November 3, 2014  
NND-14-0548  
10 CFR 50.90

Virgil C. Summer Nuclear Station (VCSNS) Units 2 and 3  
Combined License Nos. NPF-93 and NPF-94  
Docket Nos. 52-027 & 52-028

Subject: LAR 13-23 R3 Reinforced Concrete to Steel Plate Composite Construction  
Connections

**UFSAR Subsection 3H, Figure 3H.5-7 - Revise information as shown in the revised figure on the following pages.**

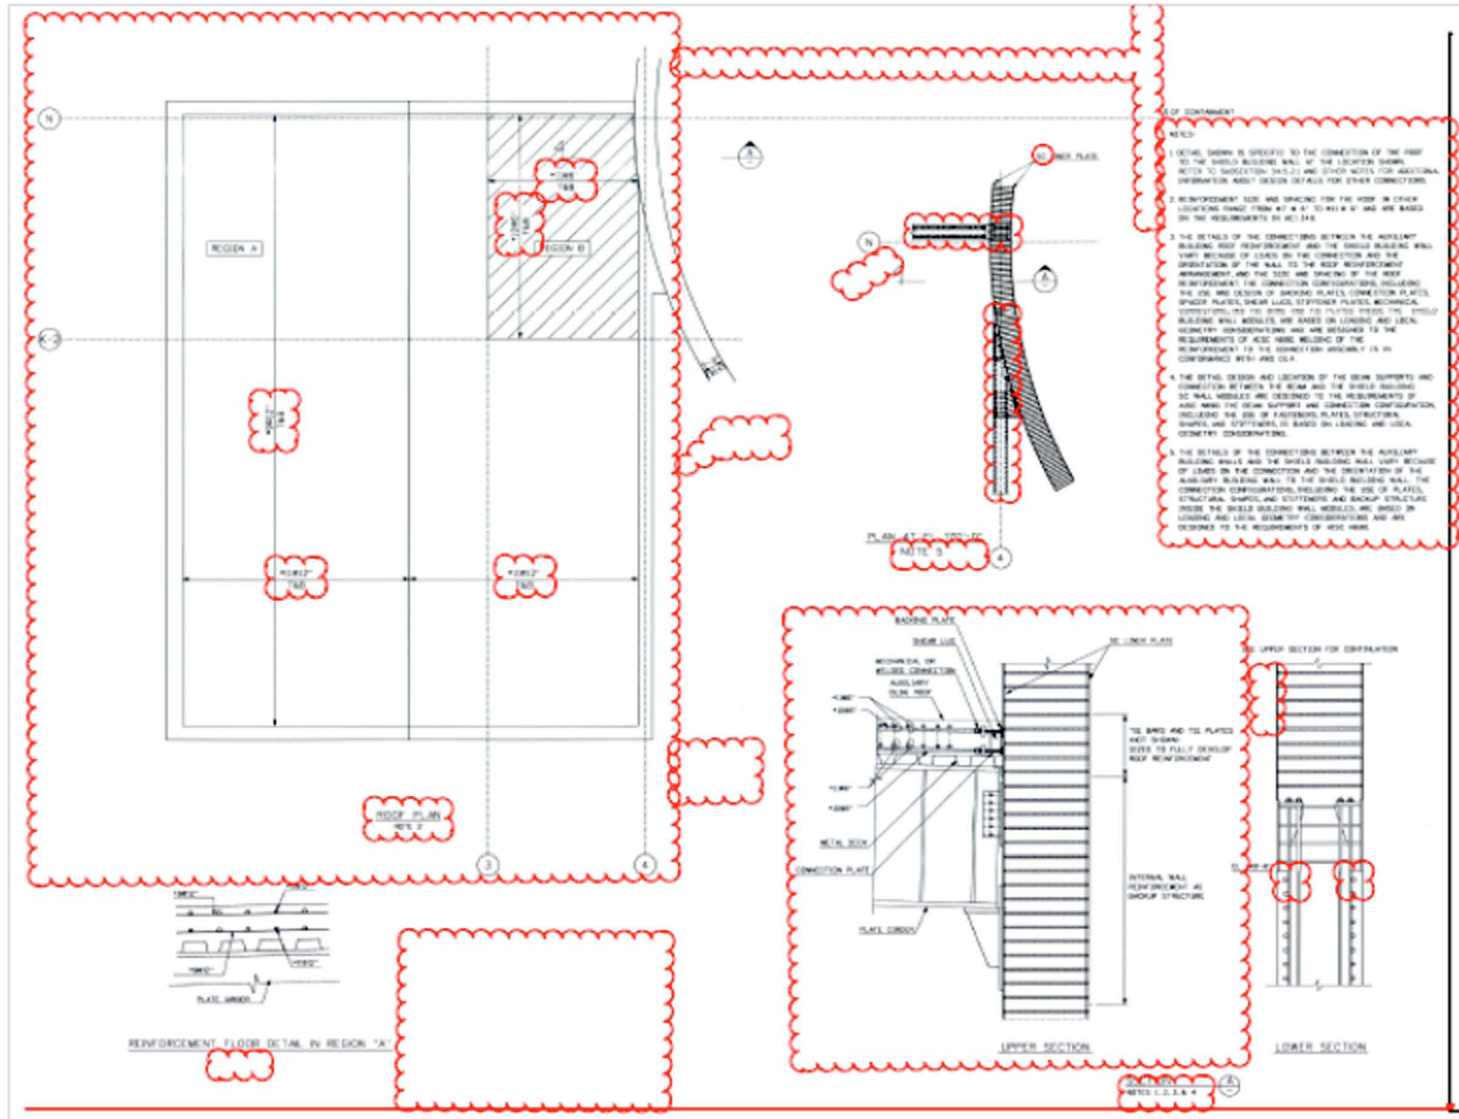
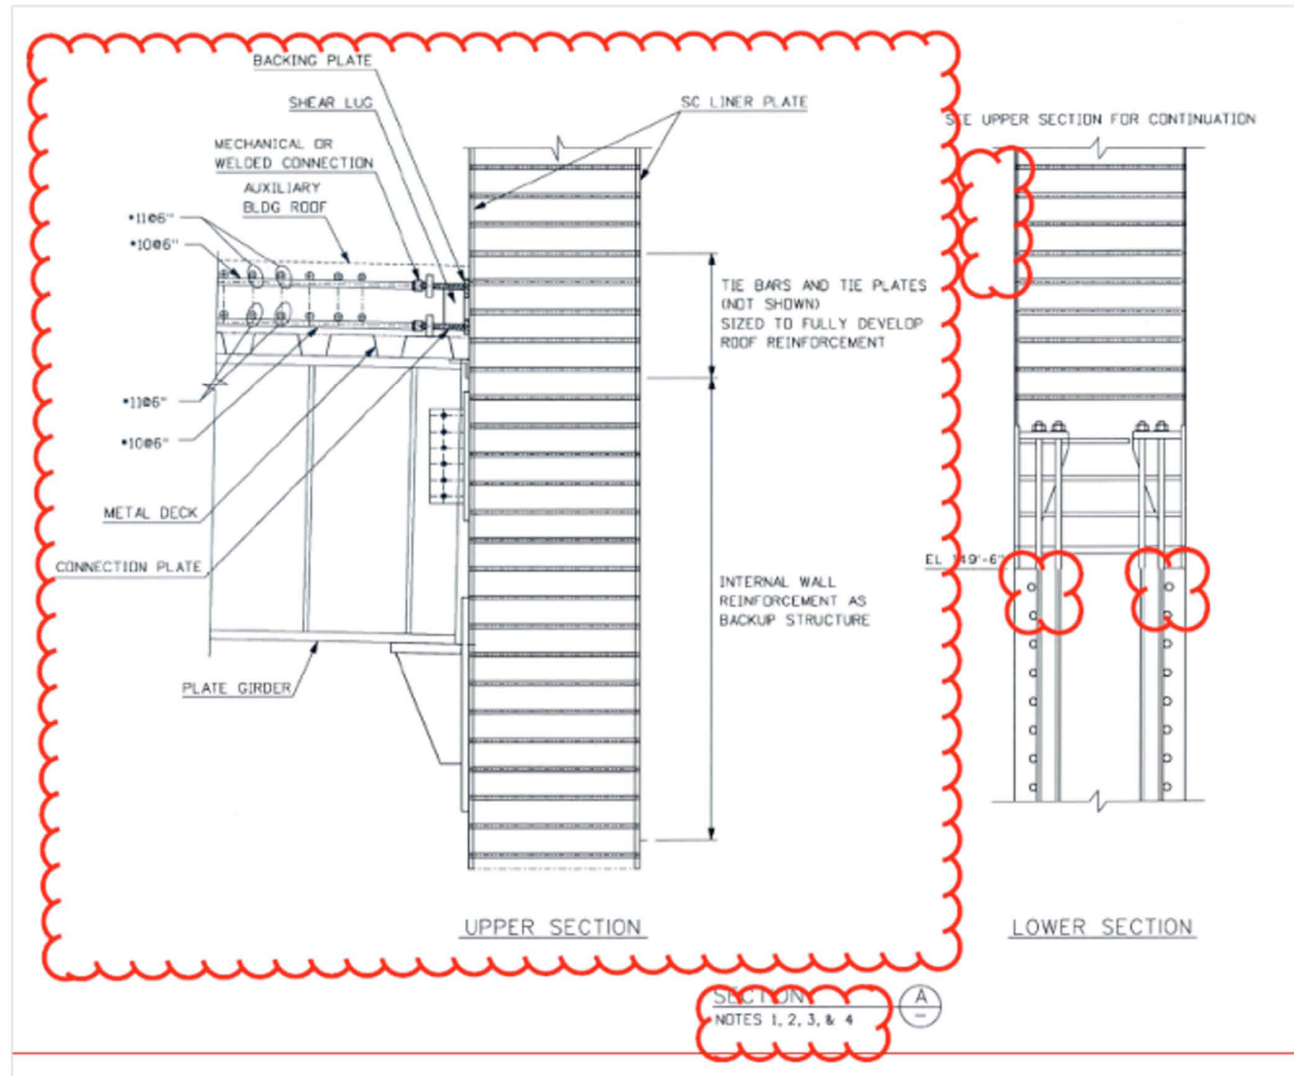
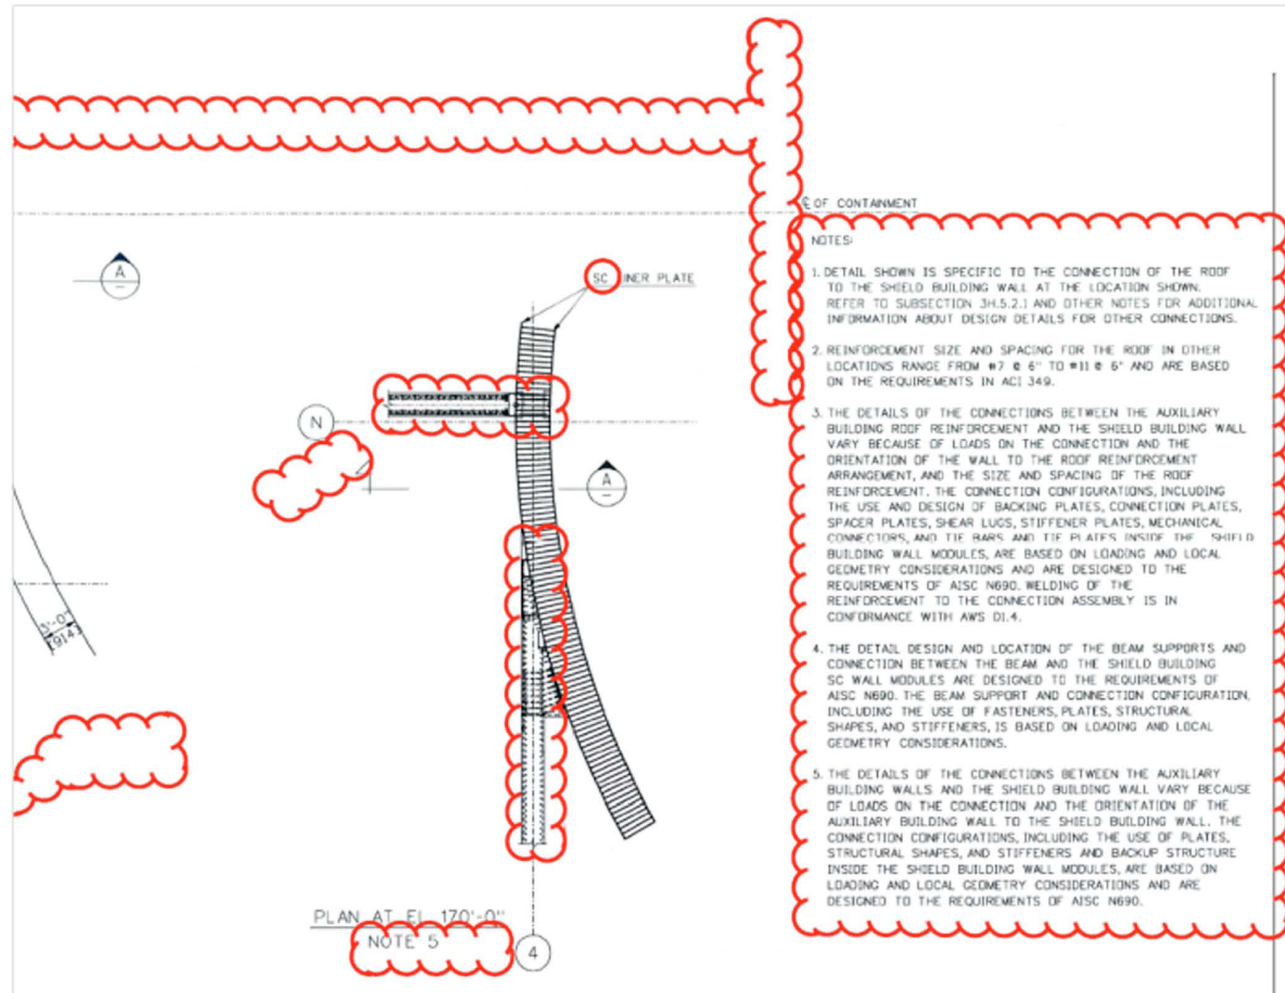
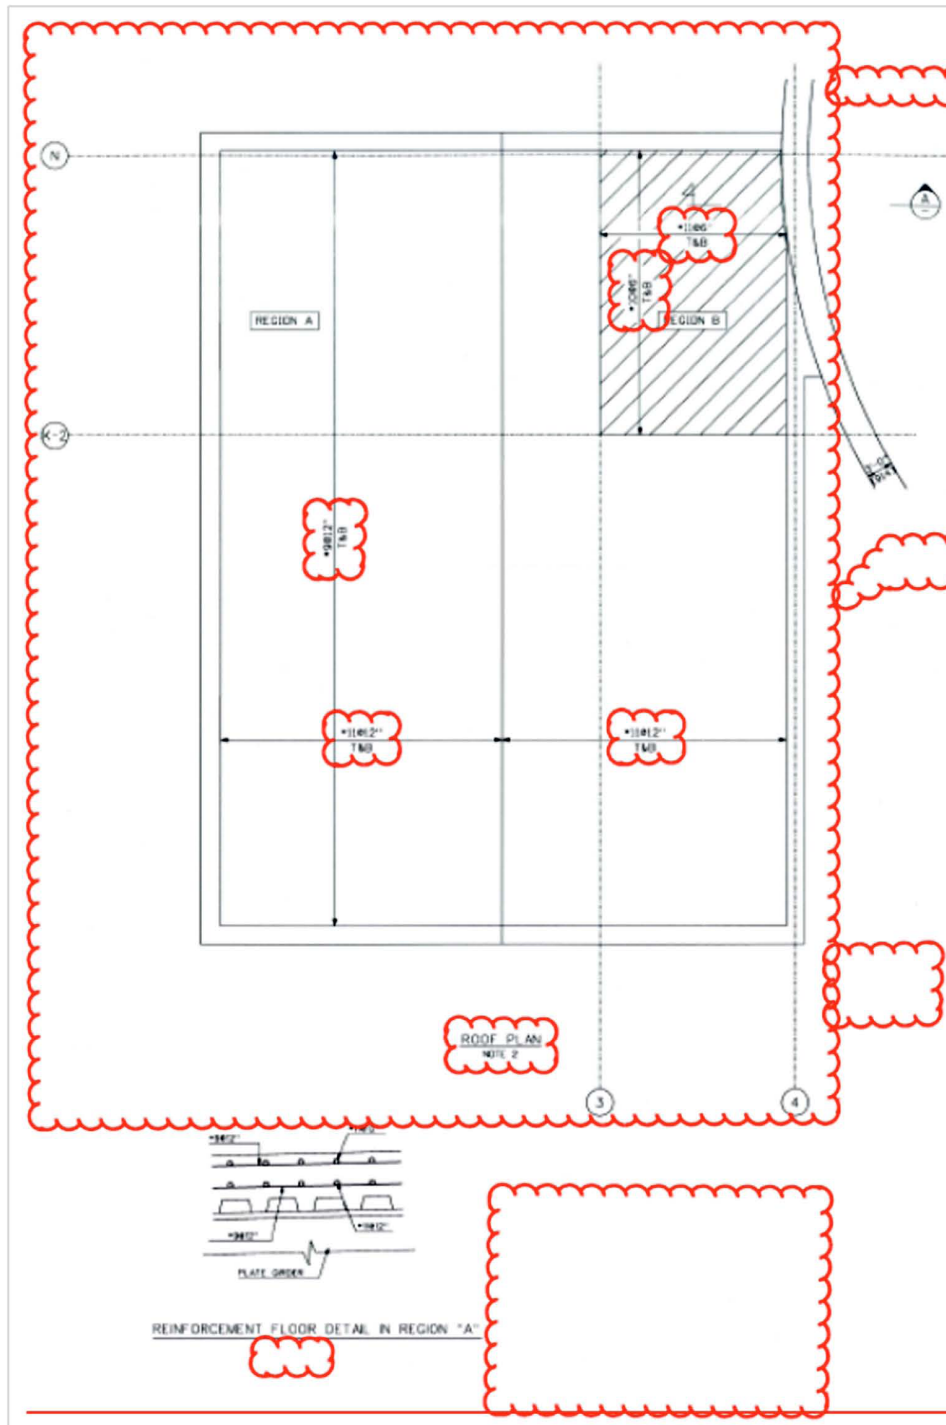
UFSAR Figure 3H.5-7 for the critical section showing the connection of the auxiliary building roof (above the radiologically controlled area of the auxiliary building) to the shield building wall also includes extraneous information unrelated to the critical section and this unrelated information is removed. This information includes the shield building wall radius and thickness and center lines which are shown in Figure 3.7.2-12 Sheet 6. Dimensions of the auxiliary building roof and walls, column lines not needed to define the critical section, distance between column lines, roof elevations, and center lines are removed. This auxiliary building information is shown in Figure 3.7.2-12 Sheets 6 and 7. The representation of the auxiliary building roof reinforcement requirement is changed such that it does not extend into the wall. The drawing scales are not appropriate and are proposed to be removed from the roof plan, the Reinforcement Floor Details in Region A, and Section A showing the connections in the roof since UFSAR figures are not to scale. The roof details provided for Region B are proposed to be removed since information for this portion of the roof is duplicated in Section A of Figure 3H.5-7. The auxiliary building Wall 4 and Wall N connection details (identified as PLAN AT EL. 170'-0") are revised. The information revised is the detail design of connections of auxiliary building wall to the shield building wall and these wall detail designs are not part of the connection of the roof to the shield building wall and are not part of the roof connection critical section. Notes are added to the figure to describe the variances in the connection detail designs.

Revise the information in UFSAR Figure 3H.5-7 as follows:

1. The Upper Section in the Section A detail showing an elevation of the roof to wall module connection information is revised to reflect changes to the connection of the roof to the wall including change in the design of the shear lug, addition of a connection plate for connection of roof reinforcement to structural modules, the addition of a stiffener plate, the addition of an connecting plate welded to the module faceplate, and the

change in the design of the connection of the girder to the wall. The extension of roof reinforcement into the wall is removed and tie bars in the wall module are designated as internal wall reinforcement to develop roof reinforcement and provide backup structure for the roof girder connection.

2. Extraneous information is removed from the roof plan including the shield building wall radius and thickness, dimensions of the roof and walls, column lines not needed to define the critical section, distance between column lines, roof elevations, and center lines and the information removed from UFSAR Figure 3H.5-7 is provided in UFSAR Figure 3.7.2-12 and Subsection 3H.5.2.2. The representation of the roof reinforcement requirement is changed to not extend into the wall. The N (North) direction indicator is removed from the upper right portion of the figure.

6. The REINFORCEMENT FLOOR DETAIL IN REGION "B" is removed since it is duplicate information to the Tier 2\* information details shown in SECTION A.
7. The tie bar spacing is removed from the Lower Section in Section A. This information is available in APP-GW-GLR-602, Figure 6.

**Figure 7, Typical Auxiliary building RC roof connection to the shield building SC wall -  
Revise the figure as shown below.**

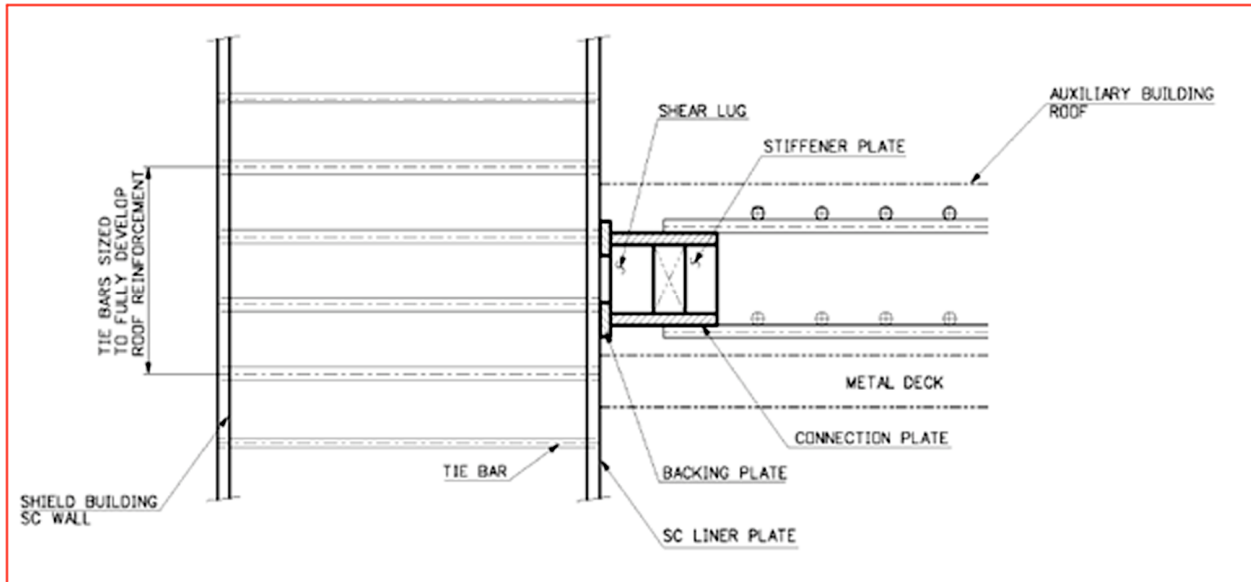
Figure 7 of APP-GW-GLR-602 showing a typical connection design for the auxiliary building roof to the shield building wall, incorporated by reference into the UFSAR, is proposed to be updated to incorporate the auxiliary building roof to shield building connection design changes described above. Notes on the figure are revised to include design requirements and design basis instead of specific reinforcement size and spacing. A note is added to reference to UFSAR Subsection 3.8.4.5.5.6.

Revise Figure 7 to show a revised connection design including:

1. The connection inside the shield building wall is provided by [through wall tie bars sized to fully develop the Auxiliary Building Roof a range of reinforcement.](#) ~~Spacing is determined along the shield building wall.~~

**Figure 6: Rollout View Detailing Nominal Spacing of Tie Bars (Viewed from SB Interior)**

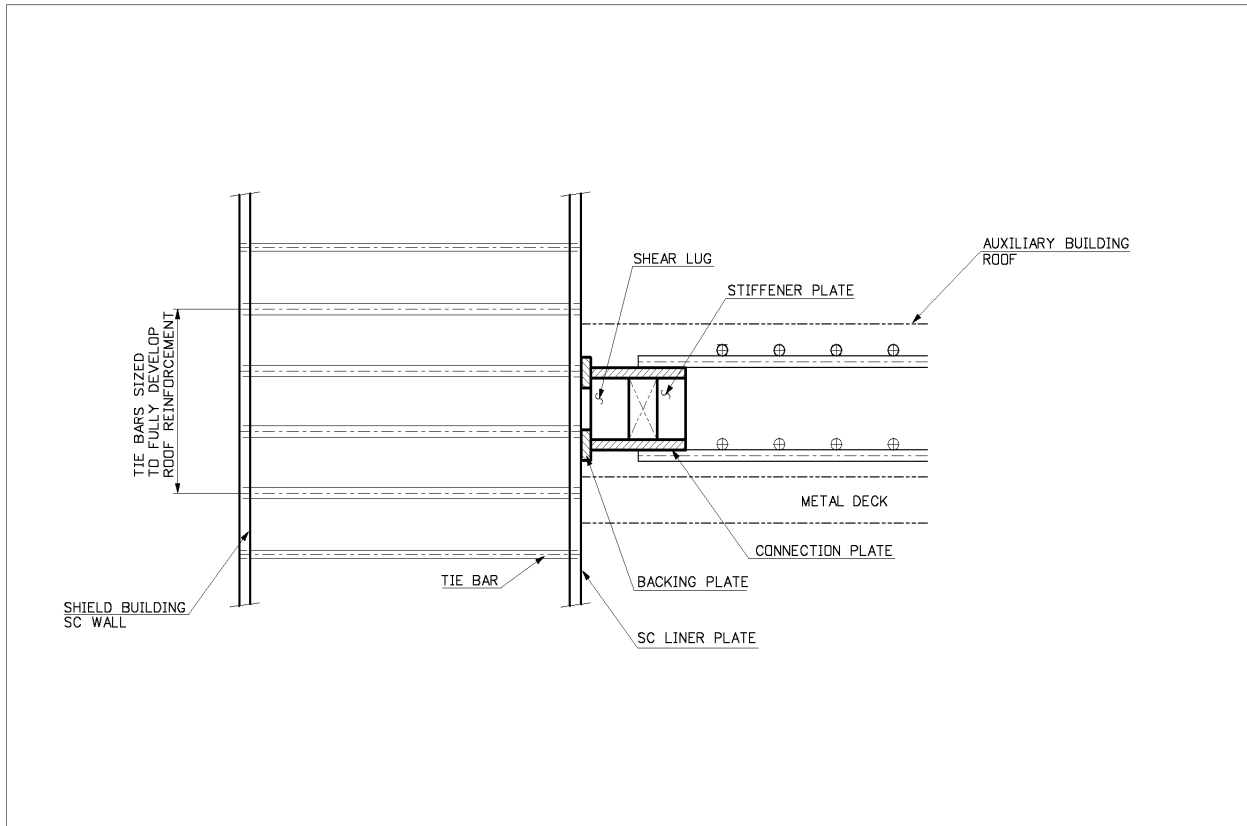
The tie bar size and spacing given in APP-GW-GLR-602, Figure 6 is the nominal design spacing required by the design demands for the structure based on limiting load combinations. An increase in the tie bar capacity may be provided to handle local attachments and connections in the area of the attachments and connections. For example, the tie bar spacing is decreased on the west side of the shield building to accommodate the attachment loads from platforms and HVAC supports. On the east side of the shield building the tie bar spacing is decreased to accommodate the attachment loads for the plant vent and stair structure. The spacing of tie bars in these areas may be equal to the spacing of tie bars in Type 1 modules. Type 1 modules are described in APP-GW-GLR-602, Section 4 and Figure 6. In local regions near wall and roof connections tie bar diameter may also be increased to accommodate the connections to the shield building. The areas with decreased tie bar spacing to address attachment loads are not identified in all cases on Figure 6 of APP-GW-GLR-602.

Revise Figure 6 to:

<b>APP-GW-GLR-602, Figure 6</b>	Revise designation of footnote (2) for Tier 2 related information from Item B to Item C	Appropriate identification of footnote applicability
<b>APP-GW-GLR-602, Figure 6</b>	Revise footnote (2) and add new footnote (3) for clarity	Separate size and spacing related footnote information
